CONSTRUCTION DOCUMENTS GRADING & EROSION CONTROL PLAN CBP, F2-LOT #21 - CRACKERJACK MUD JACKING, INC 7315 McCLAIN POINT, COLORADO SPRINGS, CO

GRADING PLAN

RAIN GARDEN DETAIL

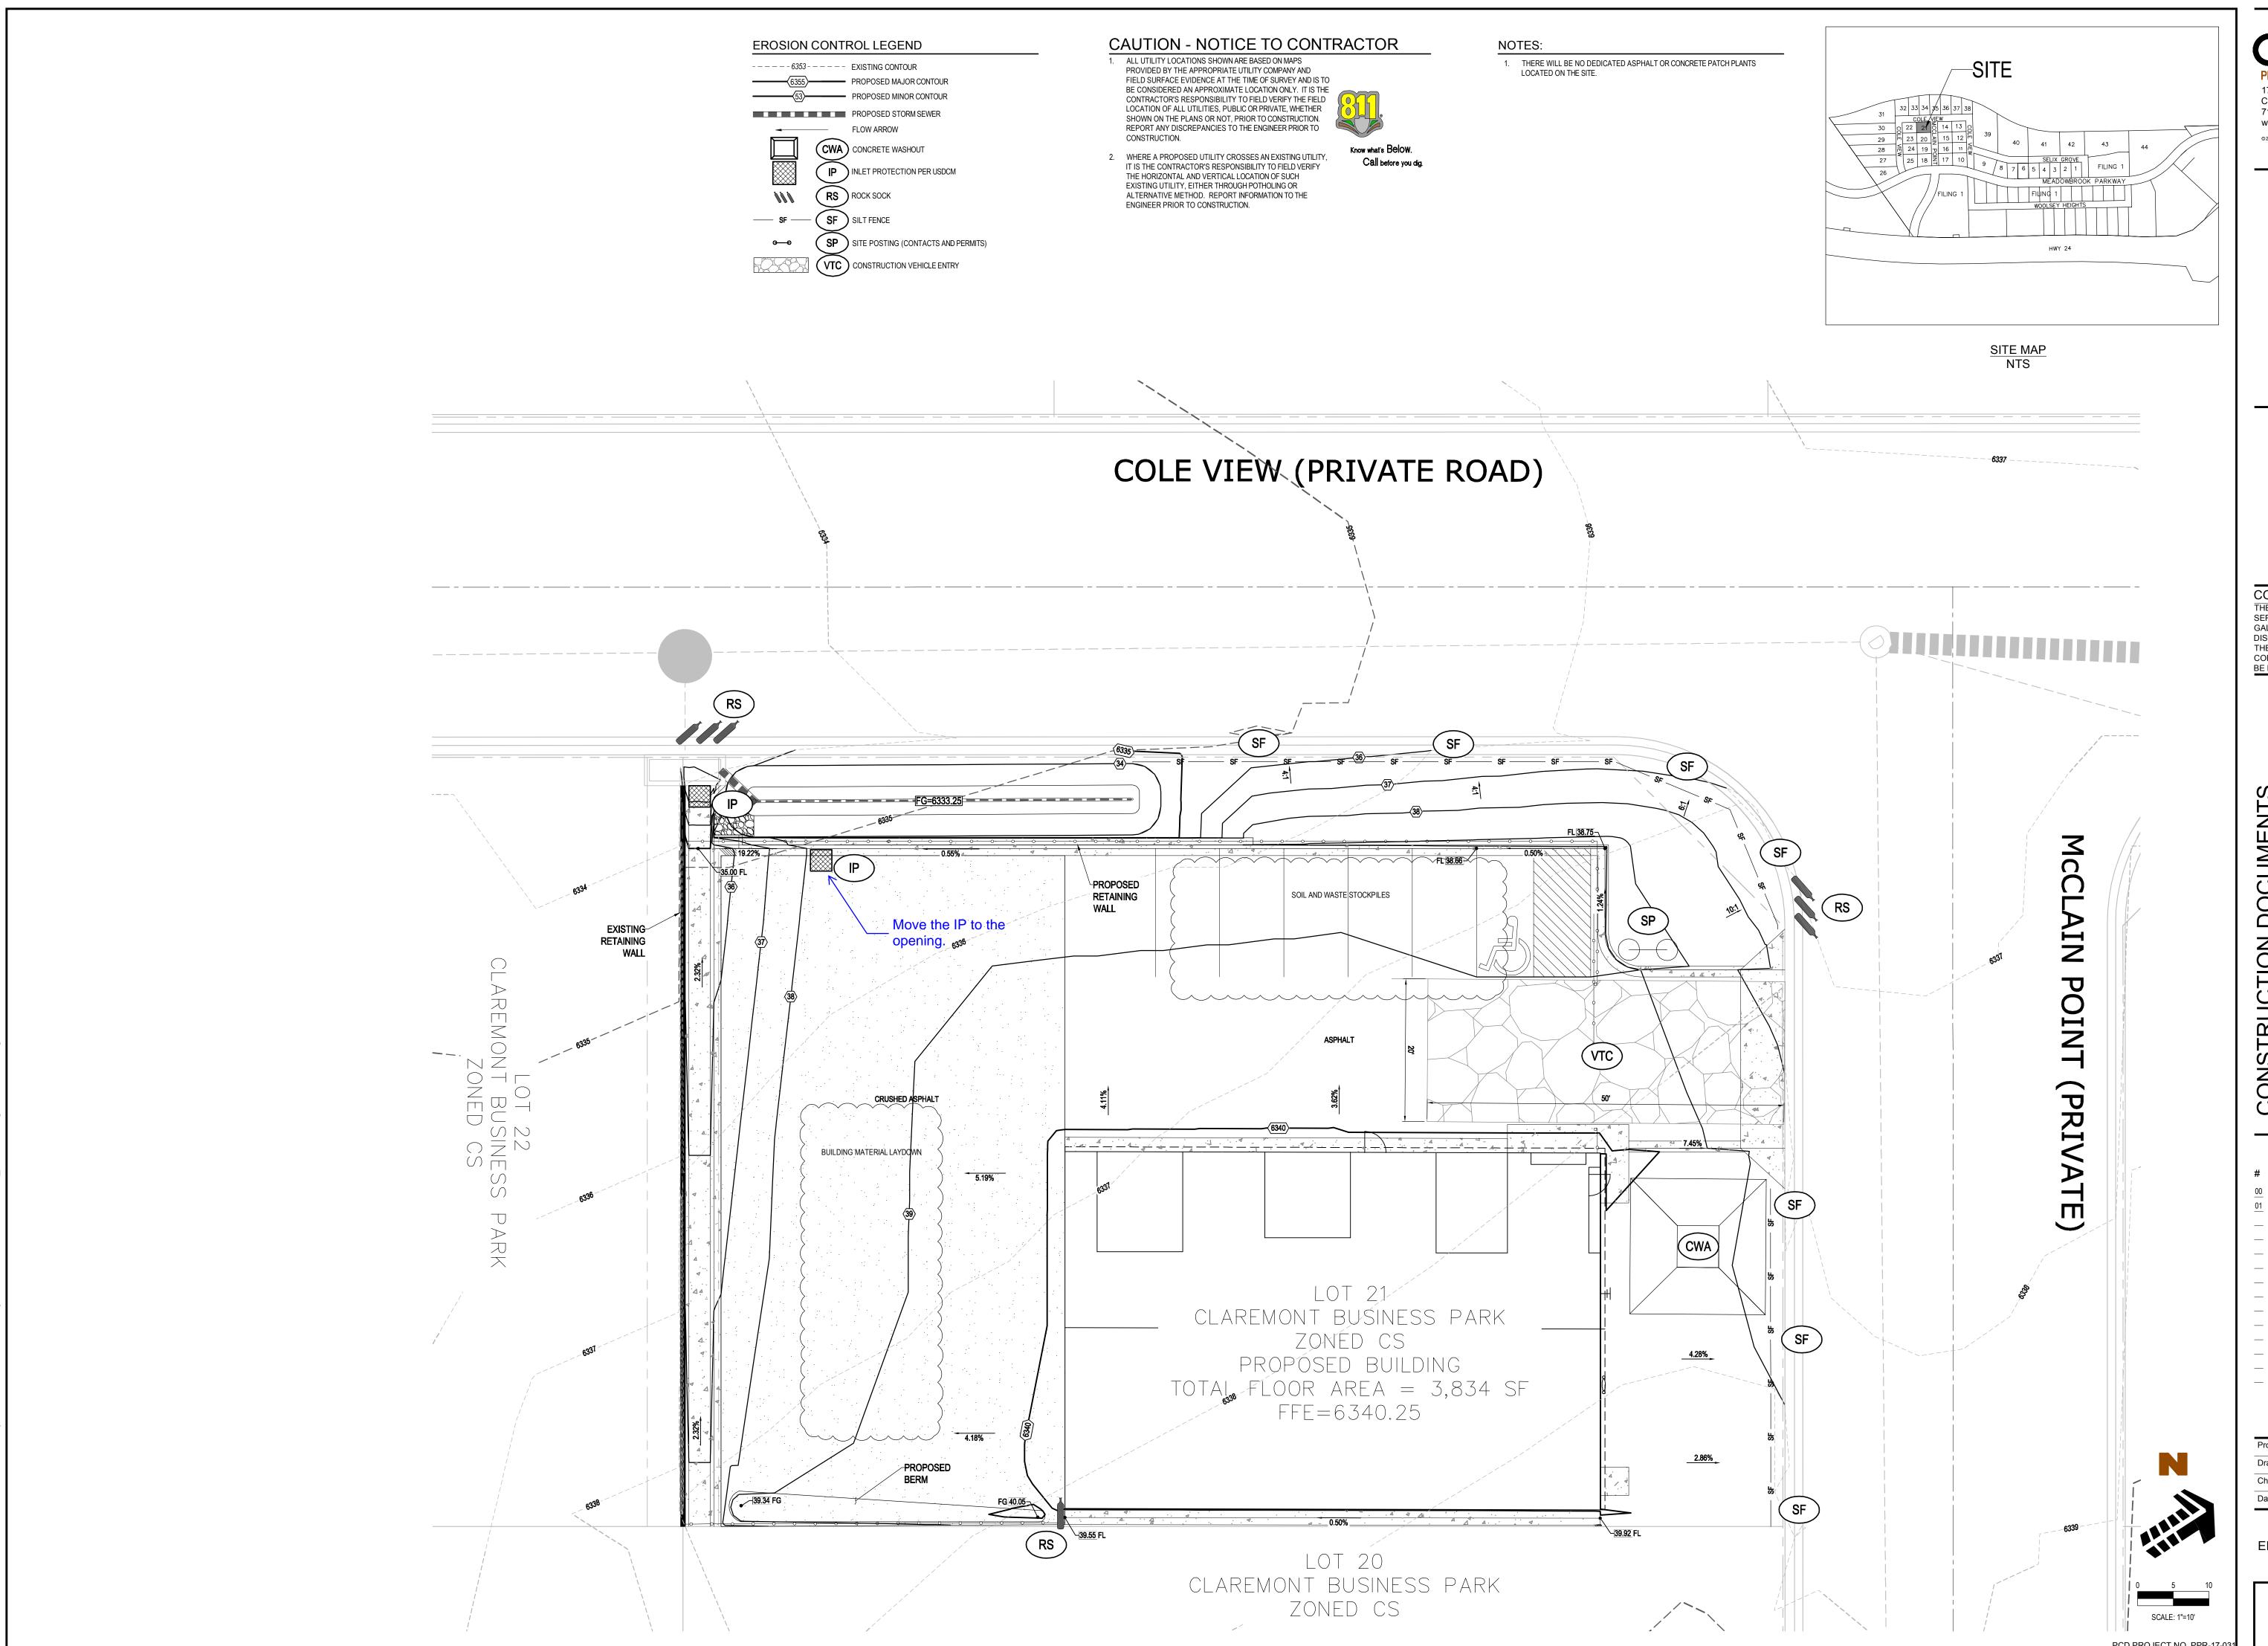
Revise the pipe size to be consistent with the drainage letter and plan view.

Provide a detail of the screen to verify the 90% open area per the drainage letter.

Revise callout. Per the detail on sheet C2.5 the filter material is a minimum 18".

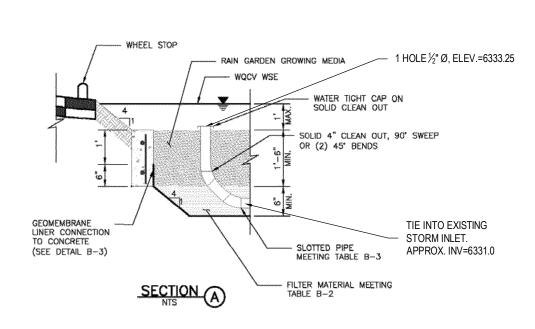
Revise the pipe size to be consistent with the drainage letter and riser pipe detail below.

Adjust so the entire callout is visible.
